Sundry Print Report

Well Name: HAFLINGER 22-27 FED Well Location: T25S / R32E / SEC 22 / County or Parish/State:

Sundry ID: 2695756

Type of Action: APD Change

WELL LOCATION AND ACREAGE DEDICATION PLAT

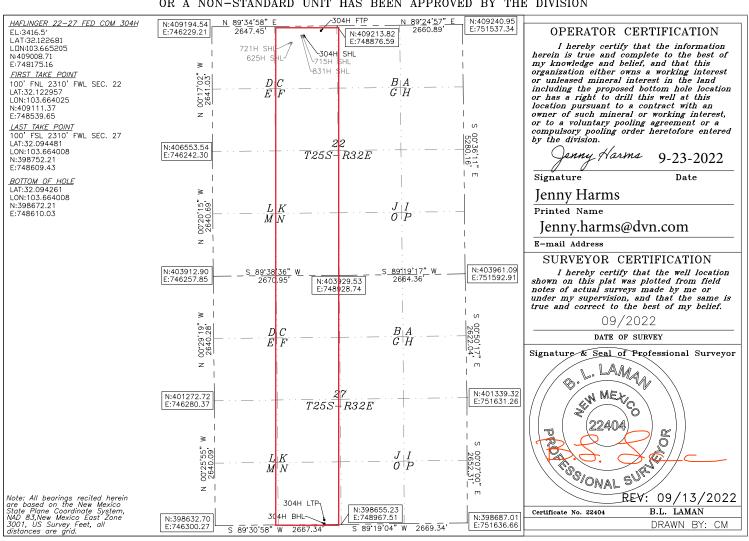
Procedure Description: SHL/BHL/NAME/DRILLING CHANGE Devon Energy Production Co., L.P. (Devon) respectfully requests to move the SHL and BHL and have a name change on the subject well. Please see attached revised C102, Drill plan(with break test variance), directional plan. Permitted SHL: NENW-22-25S-32E 350 FNL 1890 FWL Proposed SHL: NENW-22-25S-32E 200 FNL 1945 FWL – LOCATION REMAINS ON PAD Permitted BHL: SESW-27-25S-32E 20 FSL 1350 FWL Proposed BHL: SESW-27-25S-32E 20 FSL 2310 FWL Permitted Well name: HAFLINGER 22-27 FEDERAL COM 523H Proposed Well name: HAFLINGER 22-27 FEDERAL COM 304H

UL or lot No.	Section	Township	Range	Lot Idn	Feet from the	North/South line	Feet from the	East/West line	County
С	22	25-S	32-E		200	NORTH	1945	WEST	LEA

UL or lot No.	Section	Township	Range	Lot Idn	Feet from the	North/South line	Feet from the	East/West line	County
	Ν	27	25-S	32-E		20	SOUTH	2310	WEST	LEA
Ī	Dedicated Acres	s Joint o	r Infill C	onsolidation	Code Or	der No.				
	320

Section 2 - Blowout Preventer Testing Procedure

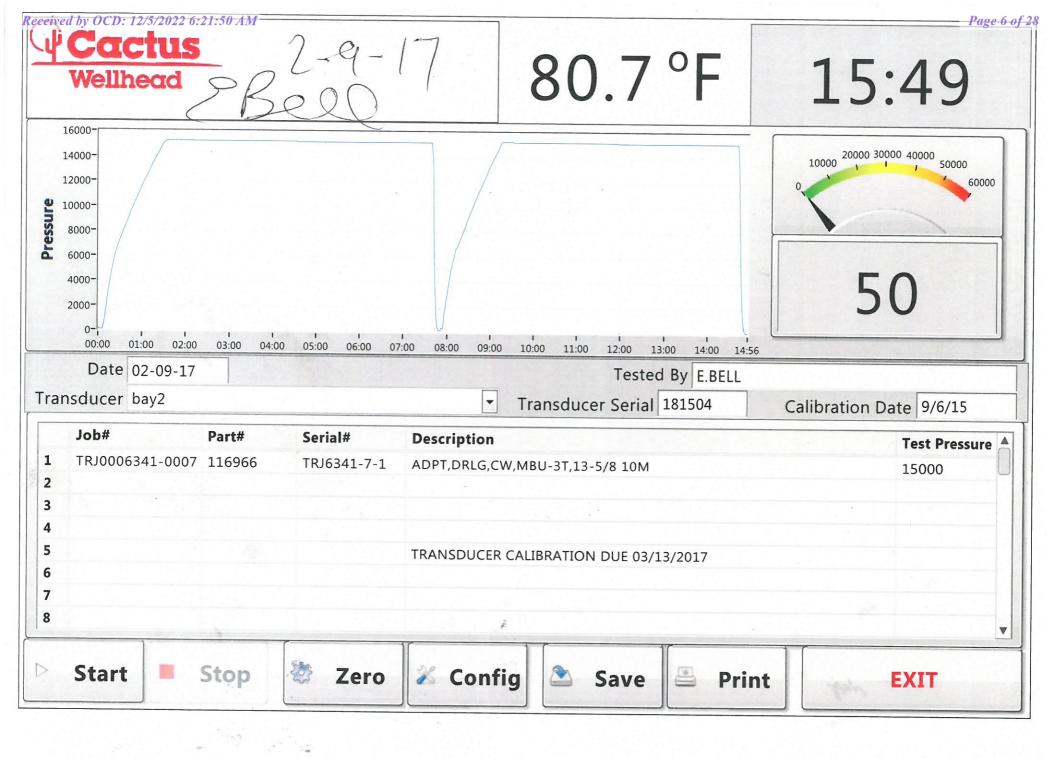
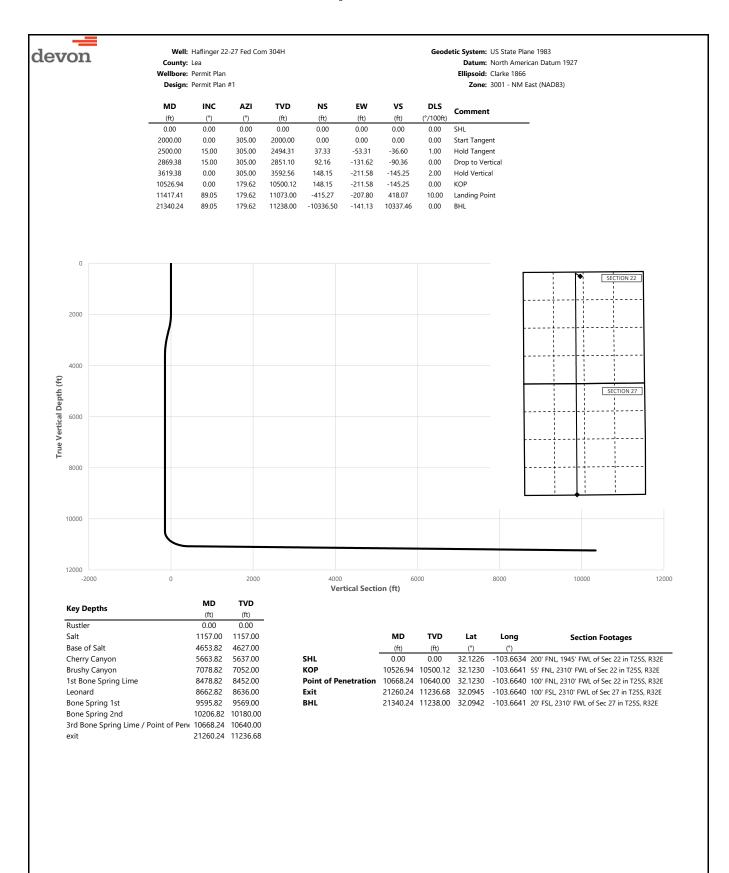
Devon Energy requests to only test BOP connection breaks after drilling out of surface casing and while skidding between wells which conforms to API Standard 53 and industry standards. This test will include the Top Pipe Rams, HCR, Kill Line Check Valve, QDC (quick disconnect to wellhead) and Shell of the 10M BOPE to 5M for 10 minutes. If a break to the flex hose that runs to the choke manifold is required due to repositioning from a skid, the HCR will remain open during the shell test to include that additional break. The variance only pertains to intermediate hole-sections and no deeper than the Bone Springs Formation where 5M BOP tests are required. The initial BOP test will follow OOGO2.III.A.2.i, and subsequent tests following a skid will only test connections that are broken. The annular preventer will be tested to 100% working pressure. This variance will meet or exceed OOGO2.III.A.2.i per the following: Devon Energy will perform a full BOP test per OOGO2.III.A.2.i before drilling out of the intermediate casing string(s) and starting the production hole, before starting any hole section that requires a 10M test, before the expiration of the allotted 14-days for 5M intermediate batch drilling or when the drilling rig is fully mobilized to a new well pad, whichever is sooner. We will utilize a 200' TVD tolerance between intermediate shoes as the cutoff for a full BOP test. The BLM will be contacted 4hrs prior to a BOPE test. The BLM will be notified if and when a well control event is encountered. Break test will be a 14 day interval and not a 30 day full BOPE test interval. If in the event break testing is not utilized, then a full BOPE test would be conducted.

- 1. Well Control Response:
- 1. Primary barrier remains fluid
- 2. In the event of an influx due to being underbalanced and after a realized gain or flow, the order of closing BOPE is as follows:
 - a) Annular first
 - b) If annular were to not hold, Upper pipe rams second (which were tested on the skid BOP test)
 - c) If the Upper Pipe Rams were to not hold, Lower Pipe Rams would be third

- BOPE Break Testing is ONLY permitted for 5M BOPE or less. (Annular preventer must be tested to a minimum of 70% of BOPE working pressure and shall be higher than the MASP)

- BOPE Break Testing is NOT permitted to drilling the production hole section.
- Variance only pertains to the intermediate hole-sections and no deeper than the Bone Springs formation.

- A full BOPE test is required prior to drilling the first deep intermediate hole section. If any subsequent hole interval is deeper than the first, a full BOPE test will be required. (200' TVD tolerance between intermediate shoes is allowable).
